Access Compliance Report

Public Rights-of-Way

(Curb Ramps)

Intersection ID: 45249	Main Street: CALDWELL_RD	Cross Street: FARMINGTON_RIDGE_PY	Location: S
ADA ID: 874E5B87464A	Ramp Type: Directional1	Initial Pass/Fail: Fail	Overall Compliance: No
		Severity Score: 12.5

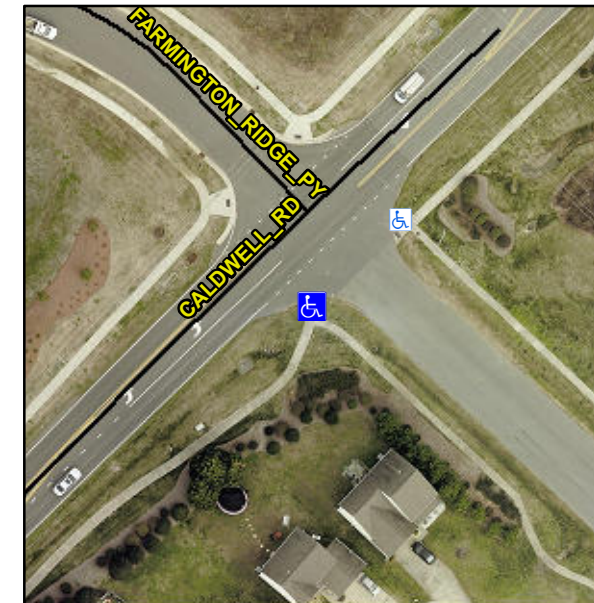
**NO CURB, NEW DEVELOPMENT NW
ACROSS CALDWELL**

R304.2.2

Compliance	Description	Data	Compliance	Description	Data
N/A	Ramp Length (in)	117.0	N/A	Grade Break?	N/A
Yes	Ramp Width (in)	58.5	N/A	Grade Break Slope (%)	0.0
No	Ramp Slope (%)	8.8	N/A	Grade Break XSlope (%)	0.0
Yes	Ramp XSlope (%)	0.5			
N/A	Flare Type LT	N/A	N/A	Flare Type RT	N/A
N/A	Flare Slope LT (%)	N/A	N/A	Flare Slope RT (%)	0.0
N/A	Flare Traversable LT?	N/A	N/A	Flare Traversable RT?	N/A
N/A	Landing Length (in)	0.0	N/A	DWS Provided?	N/A
N/A	Landing Width (in)	0.0	N/A	DWS Contrast?	N/A
N/A	Landing Slope (%)	0.0	N/A	DWS Length (in)	N/A
N/A	Landing X Slope (%)	0.0	N/A	DWS Full Width?	N/A
N/A	Landing Curb? (Y/N)	N/A	N/A	DWS Offset LT (in)	N/A
N/A	Shared Landing?	N/A	N/A	DWS Offset RT (in)	N/A
N/A	Gutter Ponding?	0.0	N/A	Gutter Slope (%)	N/A
N/A	Gutter Lip Ht (in)	3.0	N/A	Gutter X Slope (%)	N/A
N/A	Painted X Walk1?	No		Road Slope (%)	3.7
	X Walk 1 Direction	To NE		Road X Slope (%)	3.9
	X Walk 1 Width (in)	N/A		Clear Space?	N/A

Remove & Replace Entire Ramp.
